MAXIMUM SERVICE TELEVISION

Re: OET Testing of Unlicensed Devices; ET Docket No. 04-186

Proposed Modifications/Additions to the Tests Conducted by the FCC to Evaluate the Performance of Prototype TV-Band White Space Devices

Deficiencies in the OET Test Plan to Evaluate the Performance of Prototype TV-Band White Space Devices

Figure 1: I²R white-space sensing device

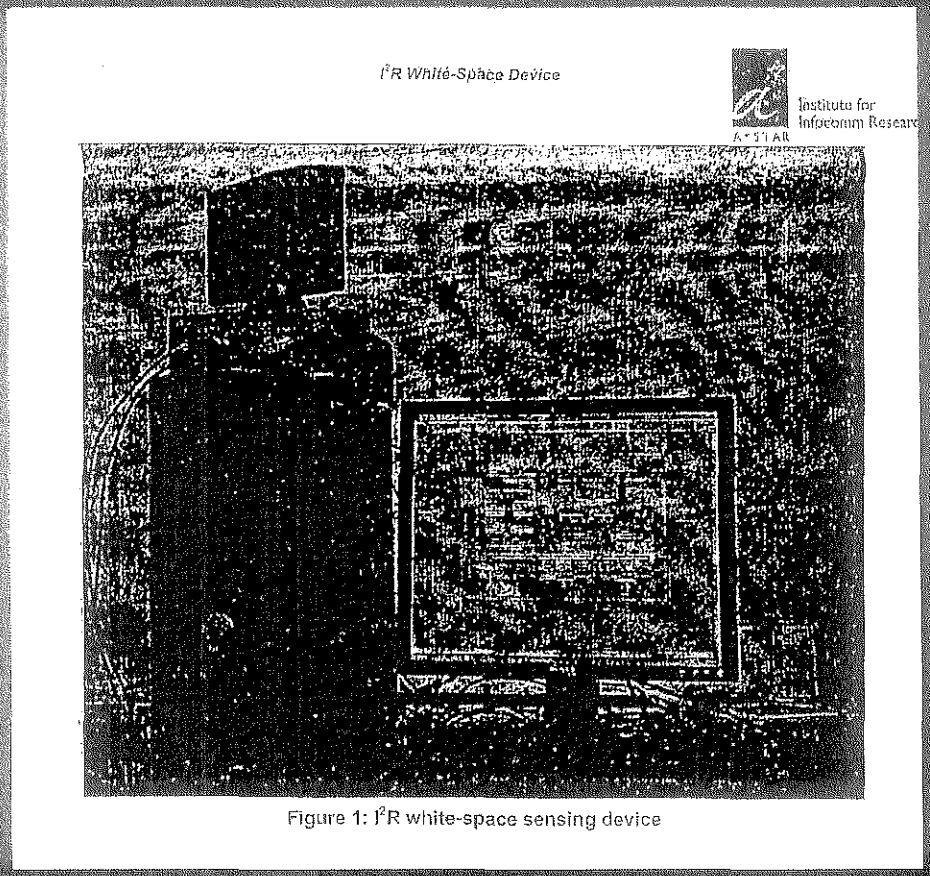
- Institute for Infocomm Research (I²R) of Singapore
- Will submit 2 identical devices
- Key Components
  - Omni antenna
  - Commercial TV tuner from Freescale
  - Mixed signal and digital processing boards
  - Computer

Antenna Performance and Sensing Level

- How do you take the antenna performance into account for sensing level
- Moore's law holds for electronics not antenna performance
- Not a particularly practical personal portable antenna design
